URGENT FIELD SAFETY NOTICE

bellavista™ Ventilators

Ceasing of Ventilation with Technical Failure Alarm 305
for Field Safety Corrective Action FSCA-2021-001

FSN Ref: FSCA-2021-001-FSN-1

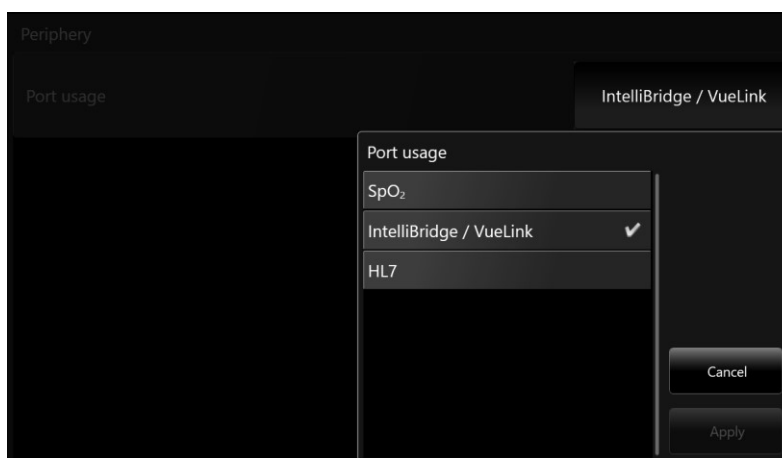
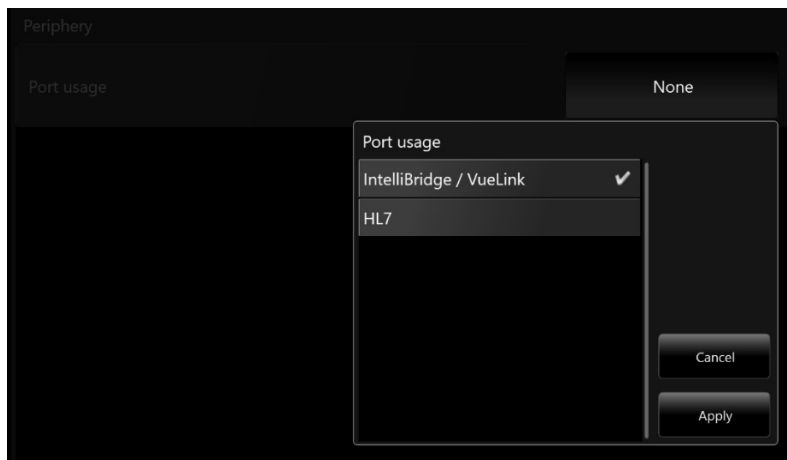
3. Ensure that **Port usage** is **NOT** configured to "HL7".

For 13.3" devices, select "IntelliBridge / VueLink" or "SpO₂".

For 17.3" devices, select "IntelliBridge / VueLink".

4. Check if patient profiles have been stored inside the ventilator with the HL7 protocol activated. If that's the case, you have to renew and store (overwrite) the profiles with the IntelliBridge/VueLink or SpO₂ setting. Otherwise, the HL7 protocol would be activated again when choosing a patient profile with HL7 protocol setting.
- Fully complete and return the signed FORM Field Safety Corrective Action (FSCA) End-User Response to imtmedical ag directly as per the instructions on the form.
 - If the failure condition described above occurs, take the device out of use and contact your imtmedical / Vyairé service partner.
